Claim Management Panel

Supplier: **AVO Carbon France (NMAP551841)**

Problem description: **lack of spring**

Claim reference: **NMAP/551841/2/2024/1675**

Ishikawa Diagram

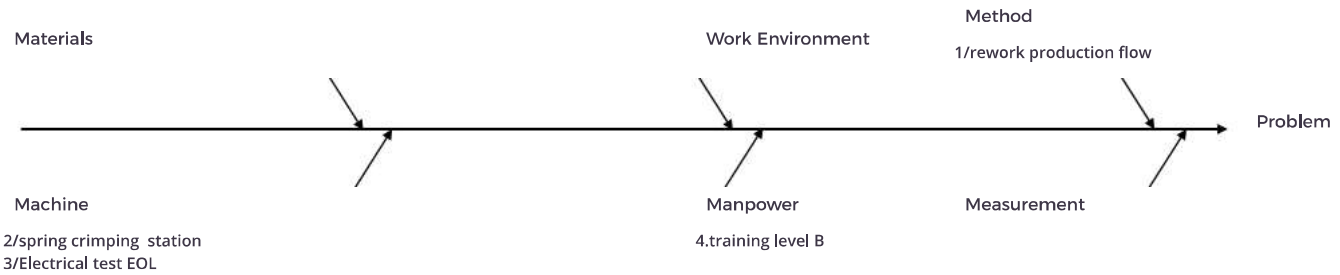
Step	Date of refusal	User name	Reason for rejection
D2-D3 Validation	3/4/2024	Dominik Dudek	"First contained shipment information:Shippement of week" ??? please enter wright shipment date and attache special label
D4 Validation	3/22/2024	Dominik Dudek	All factors from Ishikawa must be transfer to FTA.
